70 Lacey Avenue - Encroachment Appeal – Retaining Wall

Date: June 18, 2026

From: Acting Director, Street Permits, Transportation Services

3
S3.01 CONC. RETAINING WALL SECTION
SCALE: $1/2" = 1'-0"$

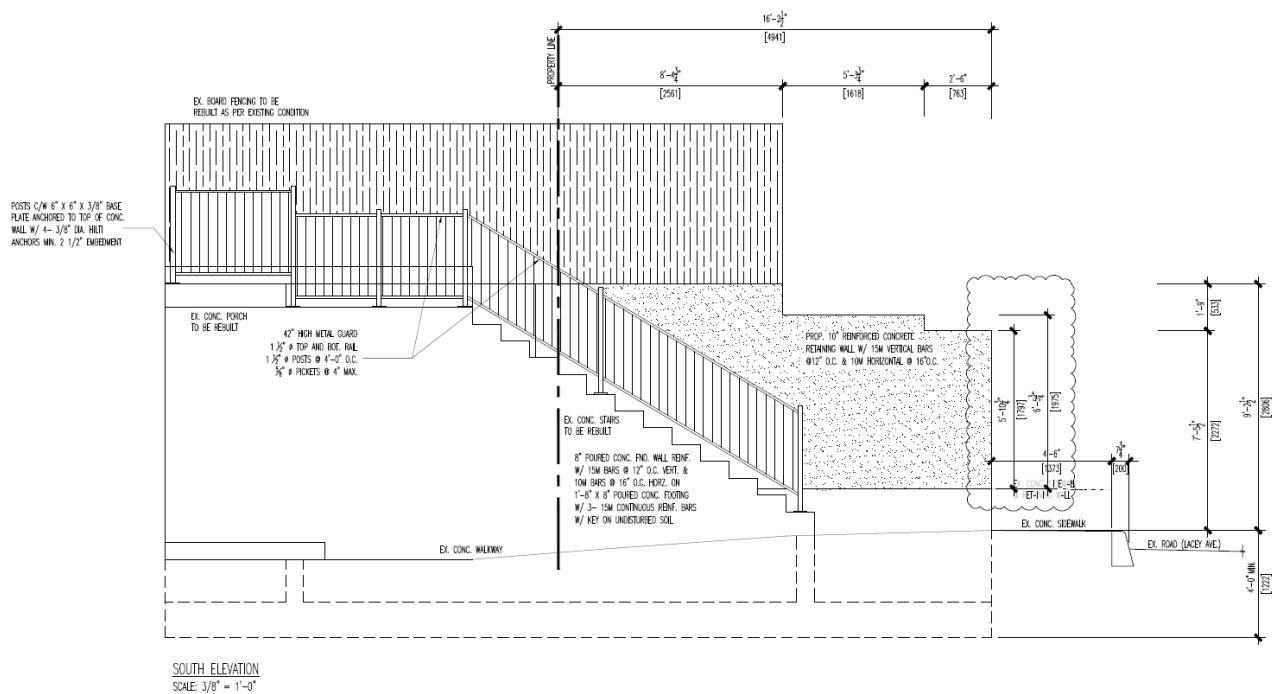
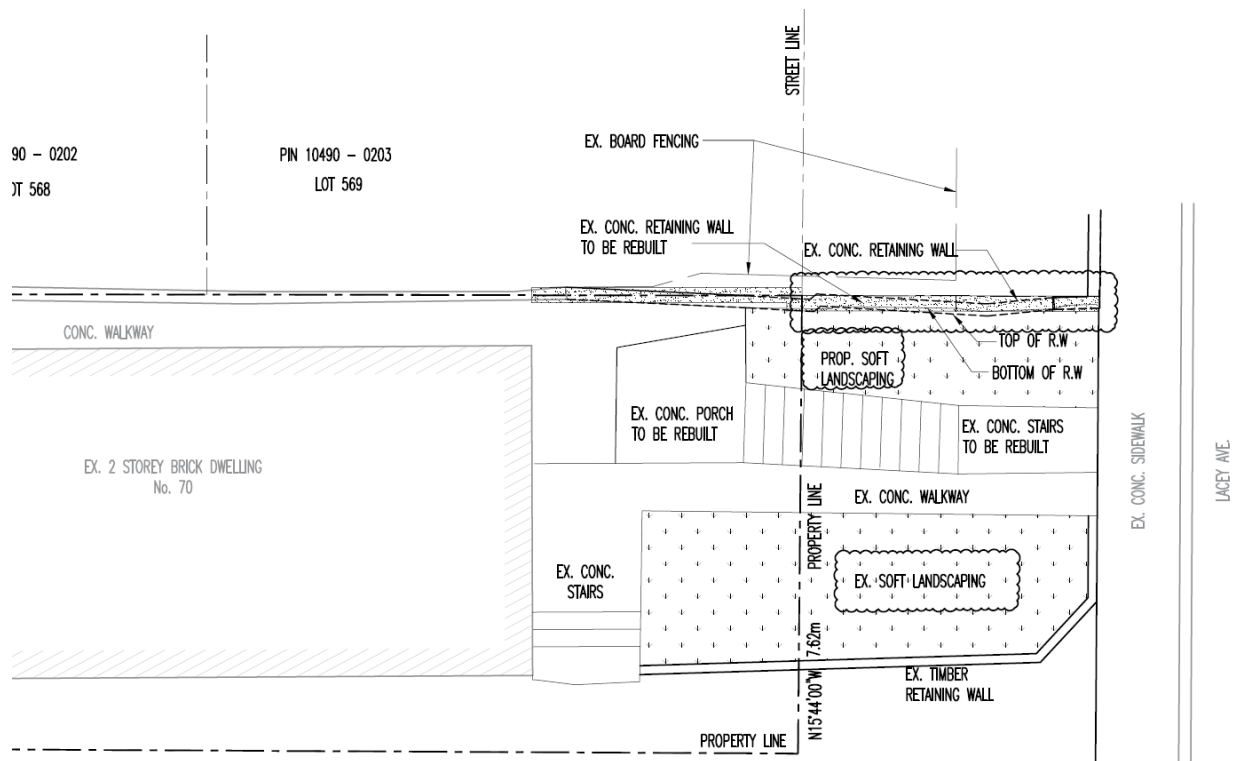
retaining wall would vary in height from approximately 1.8 metres to 2.8 metres and would include footings varying in depth from approximately 1.2 metres to 1.9 metres. The wall would be located immediately adjacent to the sidewalk, with zero setback from the public sidewalk (the "encroachment").

- The proposed retaining wall would vary in height from approximately 1.8 to 2.8 metres and is located within 70 metres of the intersection of two streets. This does not comply with Chapter 743, Section 743-34A.(2)(a)[1], which states that, "No solid screen fence, privacy fence, railing, bollard, arbour, pergola, ornamental or retaining wall located within 70 metres of the intersection of any two or more streets shall exceed a height of one metre, with the height measured from the surface of the intersecting road."

- The proposed retaining wall would extend approximately 4.9 metres into the public right-of-way and provides zero setback from the sidewalk. This does not comply with Chapter 743 Section 743-31.E.(2), which provides that "Unless otherwise specified in this chapter, no encroachments other than soft landscaping are permitted... (2) Within 0.50 metres of the edge of sidewalk located closest to the street line."

Transportation Services has reviewed the application and is of the opinion that the proposed replacement retaining wall will not adversely impact pedestrian movement, vehicular traffic on the adjacent streets, or the City's ability to access and maintain the public right-of-way. Accordingly, Transportation Services recommends that Toronto and East York authorize the encroachment, subject to the conditions outlined in this report.
